**UNITED STATES
NUCLEAR REGULATORY COMMISSION**

EA-15-081

**SUBJECT: PILGRIM NUCLEAR POWER STATION – NRC SPECIAL INSPECTION REPORT
05000293/2015007; AND PRELIMINARY WHITE FINDING**

Diagram of Target Rock SRV from NRC Information Notice 2003-01, "Failure of Boiling Water Reactor Target Rock Main Steam Safety/Relief Valve," dated January 15, 2003

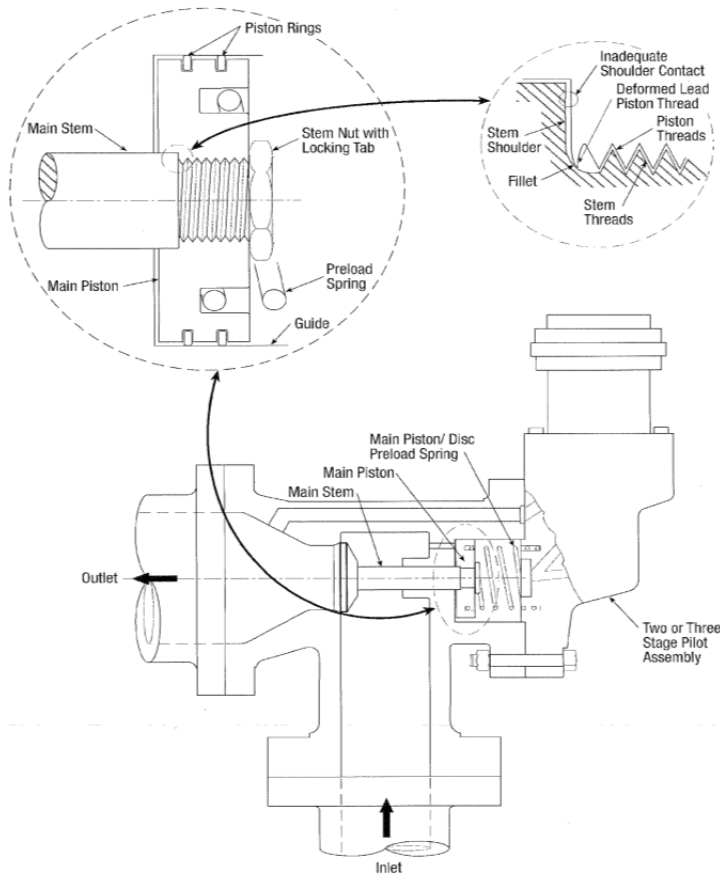
The 'C' SRV was subsequently sent to an offsite testing facility for as-found setpoint verification, low pressure testing, and an inspection of valve internal components. While the 'C' SRV satisfactorily stroked during both the setpoint test and additional low pressure (100 psig) actuation test at the testing facility, the inspection revealed notable damage to some internal valve main stage parts. Specifically, the main valve piston had indications of some scoring and the lower piston ring (two rings in total) was seized within the piston ring. The most noteworthy damage was wear (grooves) in the main operating cylinder liner where the operating piston rings rest while the valve is in its closed position. The cylinder liner wear resulted in resistance to valve operation in the open direction through contact with the operating piston rings. Upon the disassembly, the technicians noted that the piston was not tightly secured and the locking tab was slightly rotated out of its grooved position. In its normal/assembled condition, the main valve stem is threaded into the main piston, torqued, and is secured with a washer and stem nut with locking tab on the opposite side of the piston (See SRV figure below).

The assembly of the valve is such that the main stem is torqued to the piston (100 ft-lbs) and the stem nut is torqued to the threaded end of the main stem (50 ft-lbs). However, there has been prior operating experience, including an instance at PNPS in 2013, where the stem nut was found loose. Based on prior operating experience, there have been separate issues that may have contributed to torque relaxation or looseness at the stem/piston or stem nut interface. These included 1) inadequate stem shoulder contact at the main stem/piston interface, 2) inefficient test gag device that potentially allowed substantial internal valve impact during full pressure setpoint testing, and 3) a stem nut torque value that was less than optimal. It was not apparent that a single item alone was the cause for the identified issues. Further, based on historical operating and internal inspection data, internal wear problems were not assured even when the old style test gag device and lower stem nut torque existed (i.e., human performance/installation and specific in-service vibration levels may also have had negative impacts). The testing facility currently uses a re-designed test gag device to prevent a large impact force during the full pressure bench testing, and the vendor recommended an increased stem nut torque value (100 ft-lbs) in December 2013.
